UNITED STATES PATENT AND TRADEMARK OFFICE

APPLICATION NO.	FILING DATE	FIRST NAMED INVENTOR	ATTORNEY DOCKET NO.	CONFIRMATION NO.
09/804,012	03/12/2001	William R. Bennett	SP-1080.2 US	8880

Office Action Summary

DETAILED ACTION

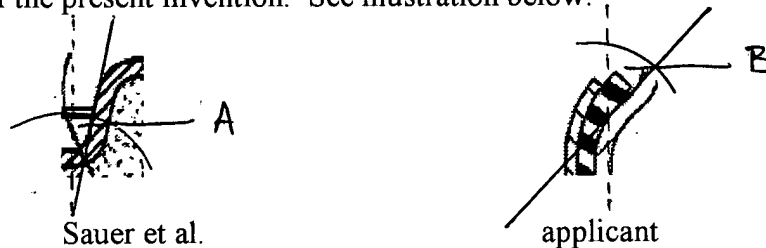
Applicant submits that in Sauer et al. the vertical portion between the step and the closed end of the anode "forms an angle of approximately 15 degrees" while the present invention is based on a disclosure wherein "substantially vertical" means no more than about 6 degrees from the vertical. However, a review of Sauer et al.'s disclosure reveals no basis for the vertical portion forming an alleged angle of approximately 15 degrees. It appears to the examiner that applicant's assertion is based on an approximation of such angle as shown in Figure 1 of Sauer et

al. Contrary to applicant's estimation, Sauer et al. is maintained to teach a substantially vertical portion in view of Figure 1 wherein the angle of the step vertical is within applicant's definition thereof as being no more than about 6 degrees from the vertical, especially in view of the angle in Sauer et al. actually being smaller, i.e. more acute from the vertical than that depicted in Figures 1 and 2 of the present invention. See illustration below:

As shown in the illustration, angle A is smaller than angle B and it is concluded that the vertical portion of the step in Sauer et al. is comfortably less than the same disclosed by applicant and therefore is also within the definition of "substantially vertical" as being no more than about 6 degrees from the vertical.
